19.2 PLANNING AND ENVIRONMENT COURT APPEAL 339 OF 2018 - HOSGOOD COMPANY 3 PTY LTD & DPK INJECTION PTY LTD (MCU013949 MATERIAL CHANGE OF USE FOR A DUAL OCCUPANCY AT 2 STARKEY STREET, WELLINGTON POINT)

PURPOSE

The purpose of this report is to provide an update to Council on the abovementioned appeal and to seek direction on the current offer to settle.

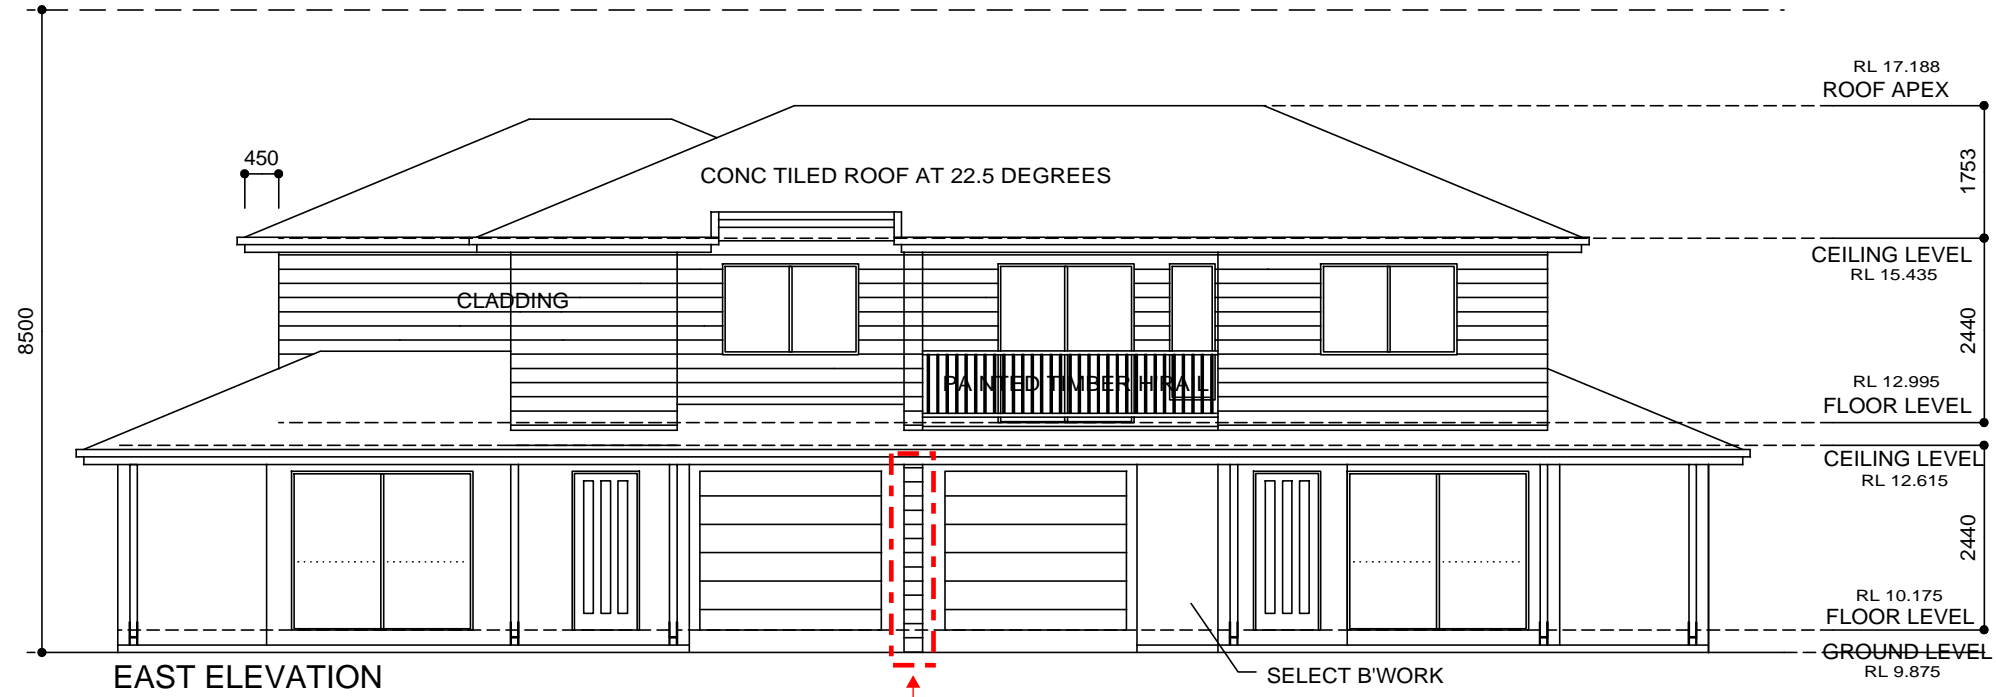
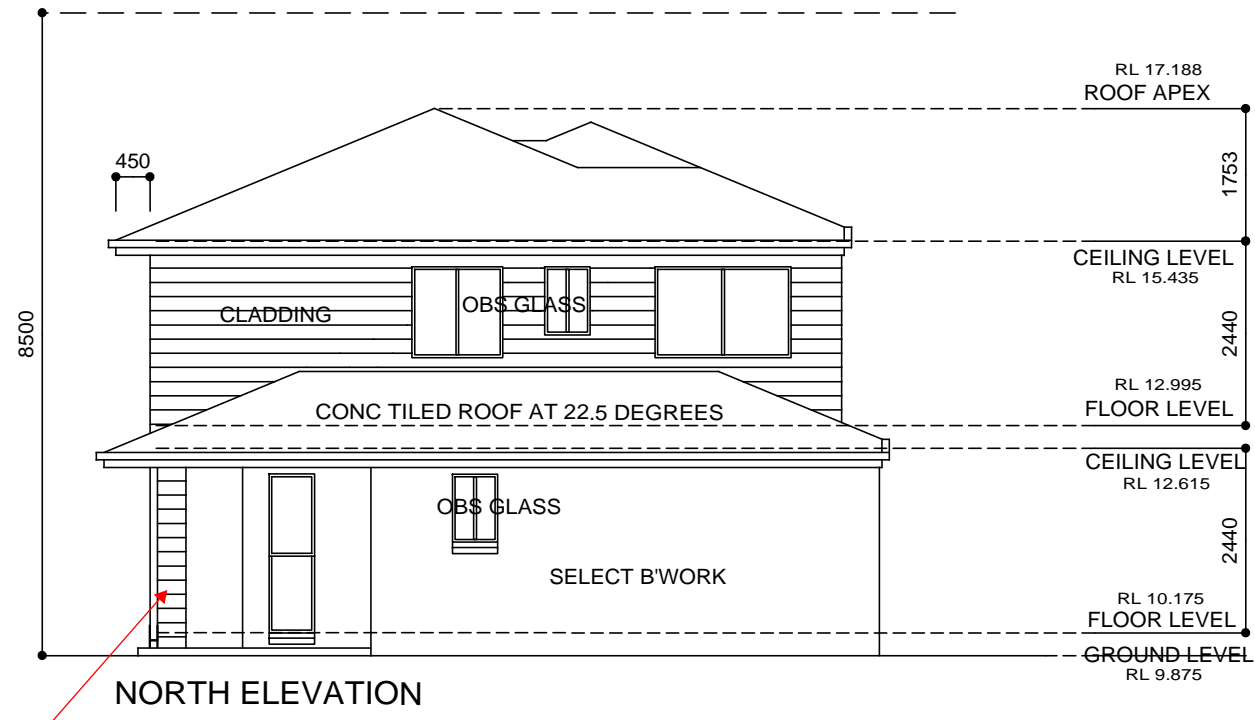
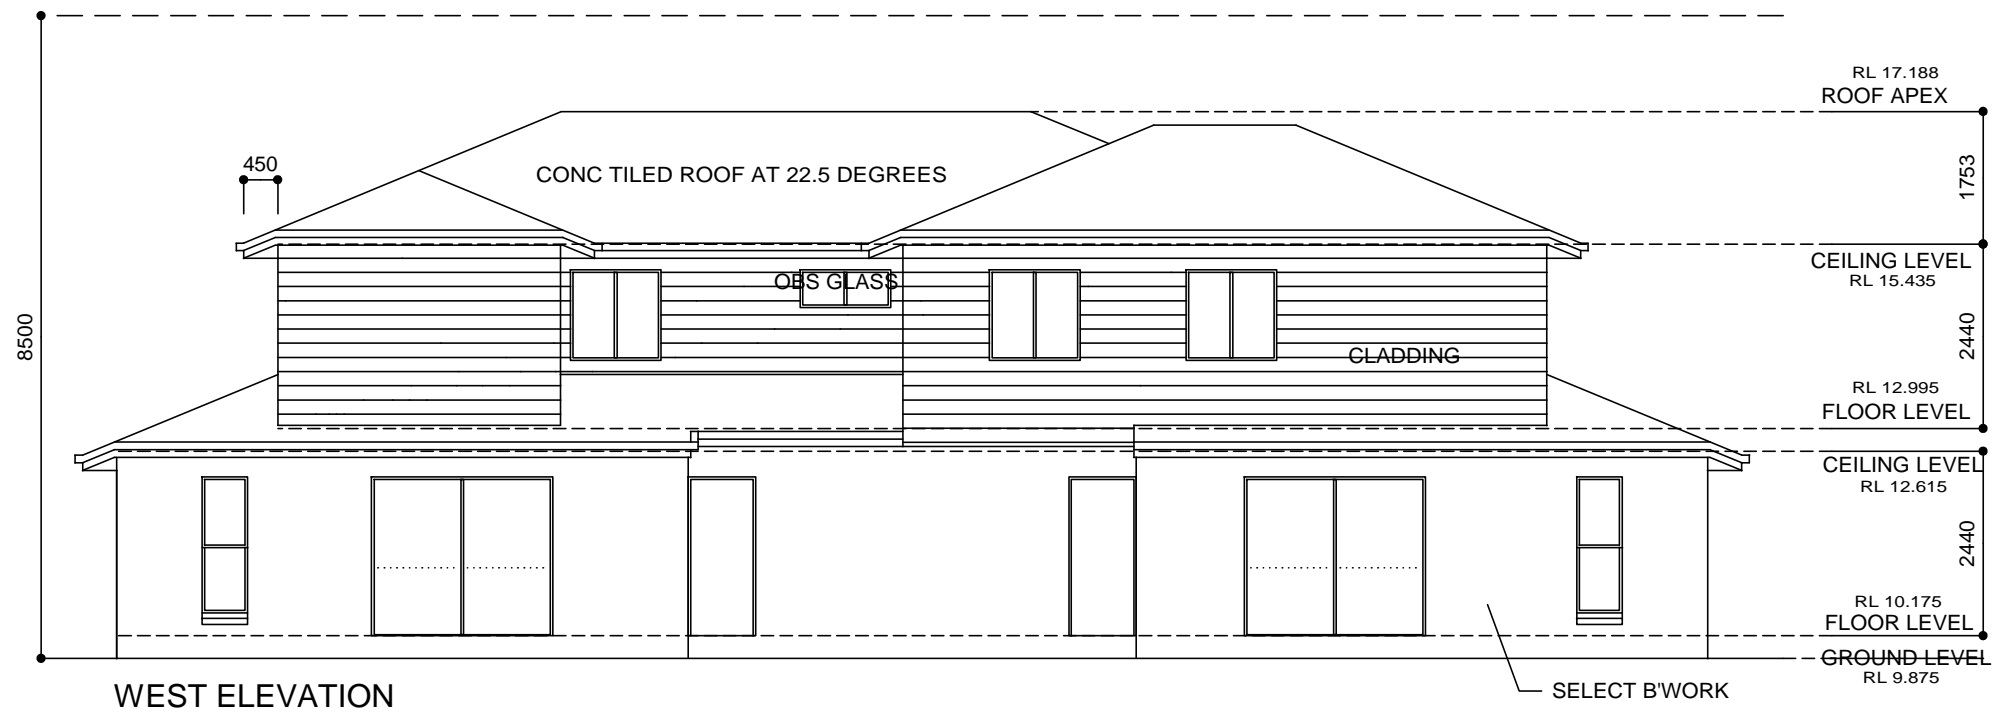
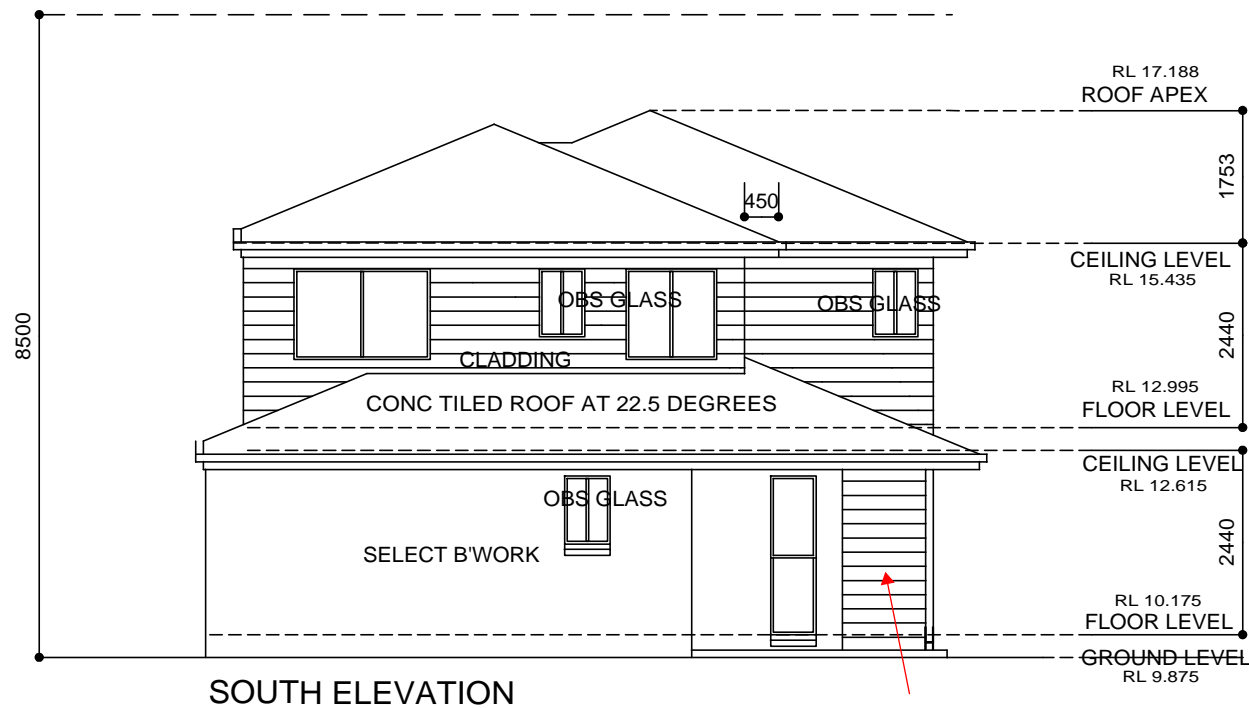
The amended design incorporates a load bearing wall at ground floor level that separates the units at the garages. There is a portion of this separating wall that protrudes in front of the garages in order to support the floor above. This wall presents as a clear divider between units and works against the design and architectural features the applicant has incorporated to ensure the building presents as one dwelling. The appearance of this wall can be diminished through the extending the garages forward to align with the building line of the living area for Unit 1. Additionally, it is recommended to be conditioned that the materials used for the wall (both on the front and sides) are the same render or brickwork as the ground floor garage openings.

IN ACCORDANCE WITH CONDITION 9 OF THIS APPROVAL THE GROUND FLOOR DIVIDING WALL BETWEEN GARAGES MUST BE THE SAME FINISH (I.E. RENDER OR BRICKWORK) AS THE GARAGE OPENINGS

IN ACCORDANCE WITH CONDITION 9 OF THIS APPROVAL THE GROUND FLOOR DIVIDING WALL BETWEEN GARAGES MUST BE THE SAME FINISH (I.E. RENDER OR BRICKWORK) AS THE GARAGE OPENINGS

IN ACCORDANCE WITH CONDITION 9 OF THIS APPROVAL THE GROUND FLOOR DIVIDING WALL BETWEEN GARAGES MUST BE THE SAME FINISH (I.E. RENDER OR BRICKWORK) AS THE GARAGE OPENINGS
